# Report to the Australian Energy Regulator

## Murraylink Proposal May 2012: Report on Engineering Issues

Final October 19, 2012

Figure A1: Graph generated by Murraylink from AEMO data, showing samples of Murraylink flow over one year, with network constraints for each direction of flow, and marks showing where the flow was constrained.

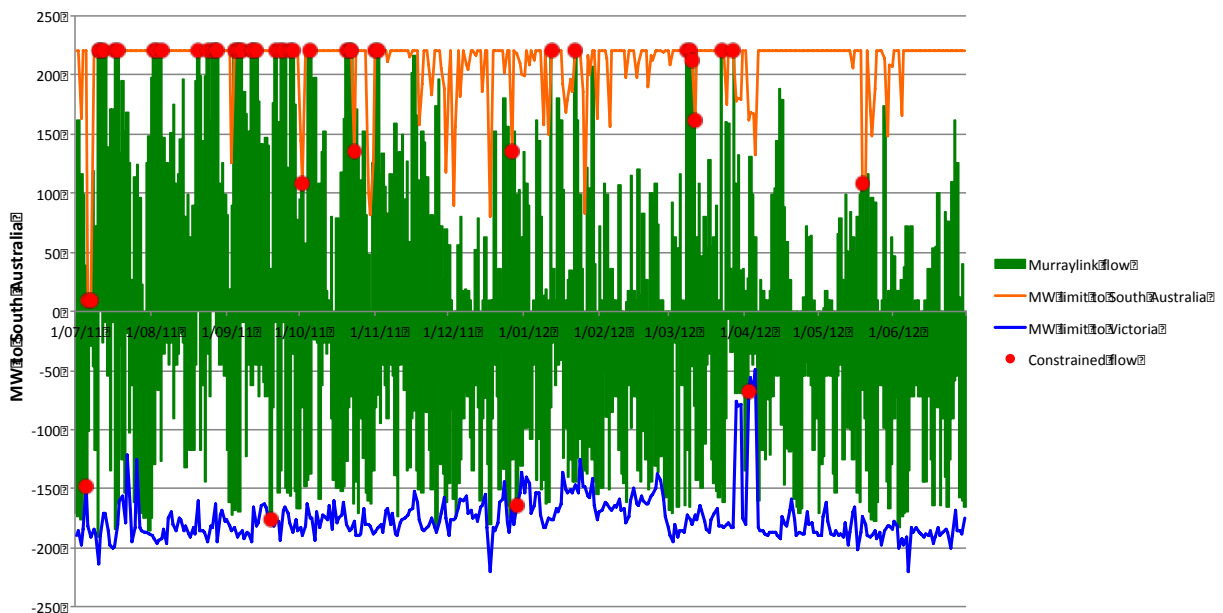
CHC noted that the flow samples used to generate figure A1 are the snapshots at midnight on each day of the year, and considered that this sample might not be typical of daily power transfers, since at this time of day network demand is relatively low, and therefore the constraints would also be less severe than at other times of the day.

CHC conducted additional analysis to include all the data throughout the year.
